**ON-SITE SEWAGE DISPOSAL SYSTEM
 HOWARD COUNTY HEALTH DEPARTMENT
 BUREAU OF ENVIRONMENTAL HEALTH**

SUBDIVISION: Hedgerow LOT NUMBER: 26

ADDRESS: 13604 Gilbride Lane PROPERTY OWNER: Chandhok

SITE PLAN

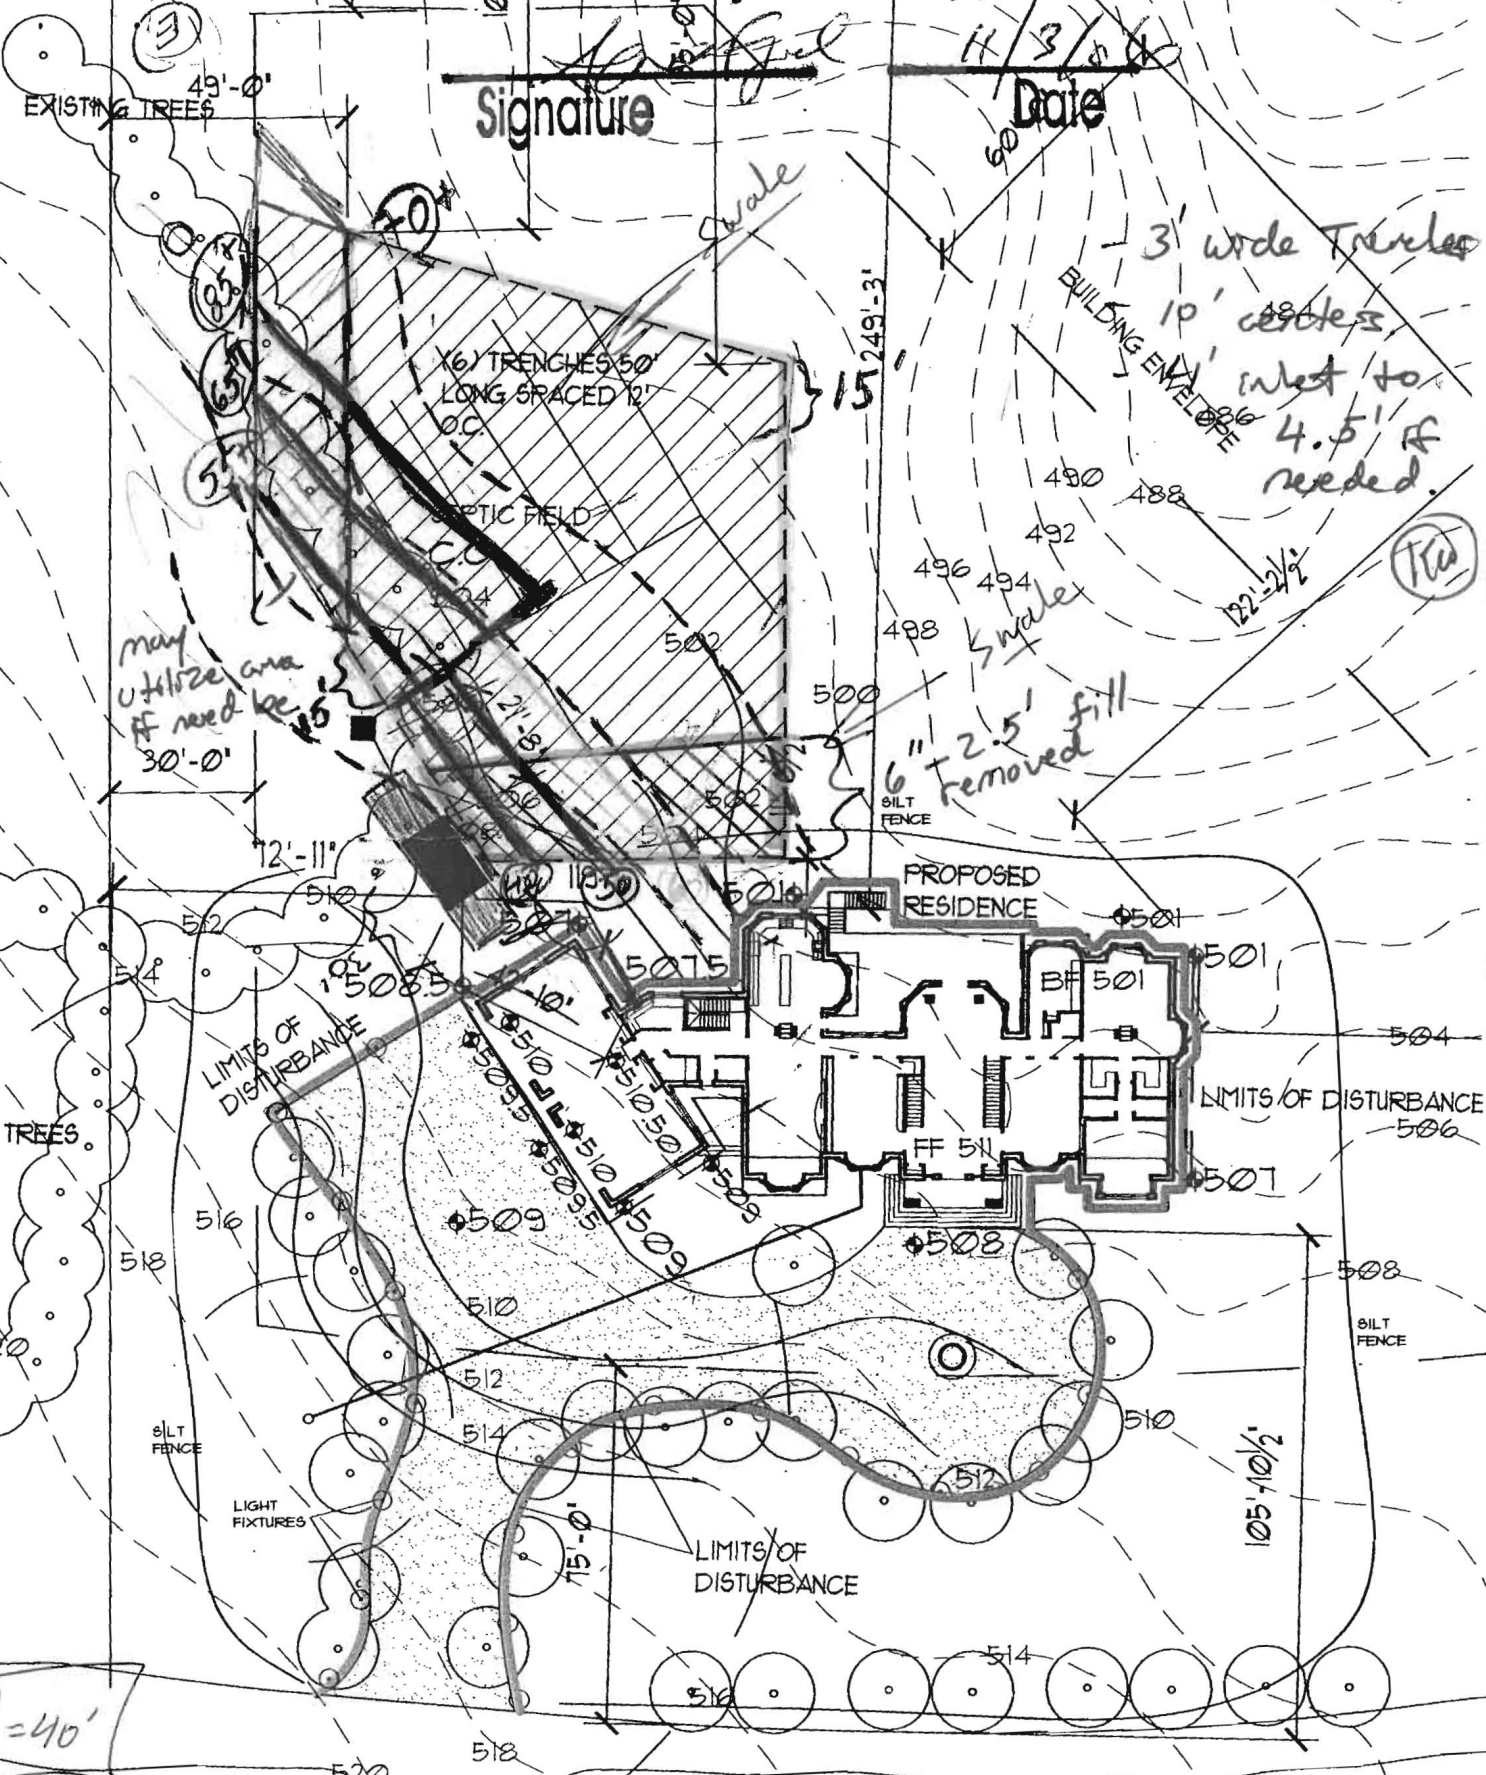
HO-94-3/53
 PRE-CONSTRUCTION 12/18/06 Septic Area not staked. No layout.
12/28/06 sets Tanks and Dbox shown per plan. Run
 INSTALLATION feed lines parallel west side SDTA run trenches
 back towards house to total 305' of trench. Need
 site verification of "laid-out" trenches before installation.
 Stayed for digging of tank hole (KW) 12/29/06. Determined
 roughly 2' of fill bottom half of septic area. Builder and
 owner notified. Contractor to remove fill. No layout (KW) 1/2/07
 Set Dbox per plan, install 5 trenches on contour.
1/3/06 O.K. to backfill. Need house connection (BB) 6/21/07
 FINAL INSPECTOR [Signature] DATE OF APPROVAL 6/21/07

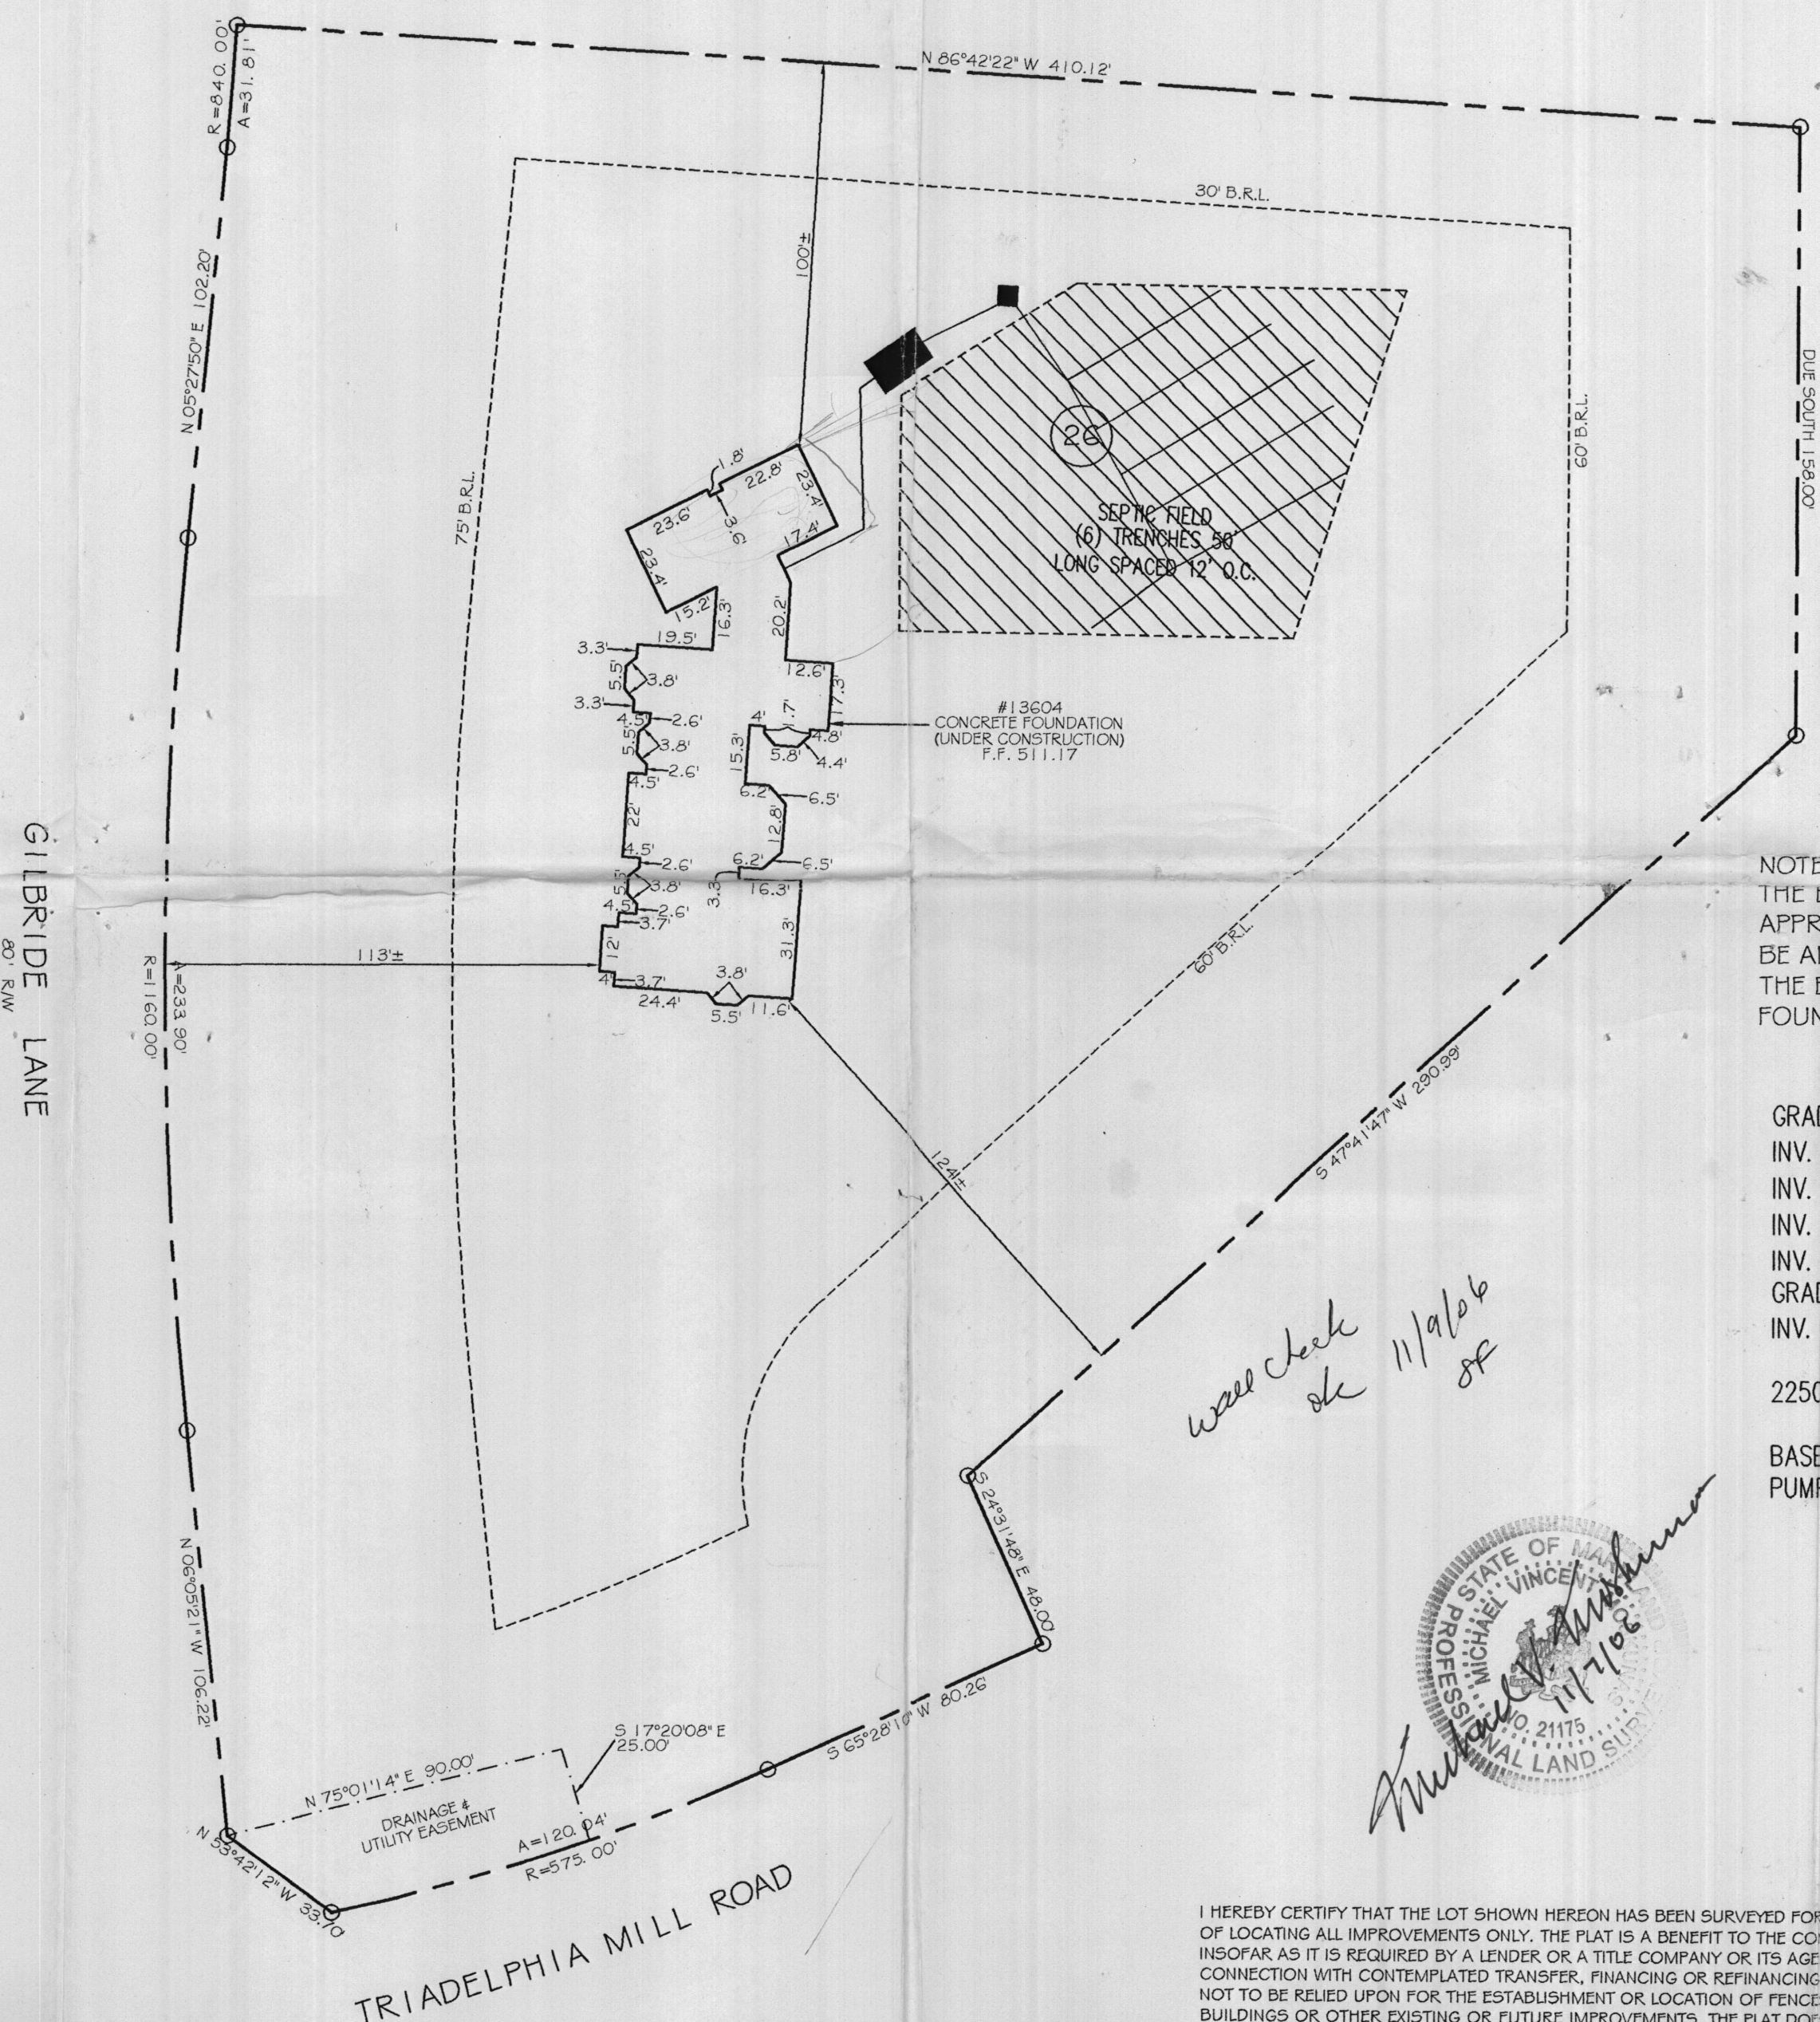
NOTE:
 THE ELEVATIONS PROVIDED PER THE
 APPROVED SITE PLAN WILL NEED TO
 BE ADJUSTED IN THE FIELD DUE TO
 THE EXISTING LOCATION OF THE
 FOUNDATION

GRADE ELEV. @ DIST. BOX = 507.5
 INV. ELEV. (INTO) TRENCH = 503.5
 INV. ELEV. (INTO) DIST. BOX = 504
 INV. ELEV. (OUT OF) SEPTIC TANK = 504.5
 INV. ELEV. (INTO) SEPTIC TANK = 505
 GRADE ELEV. @ SEPTIC TANK = 508
 INV. ELEV. (OUT OF) HOUSE = 506
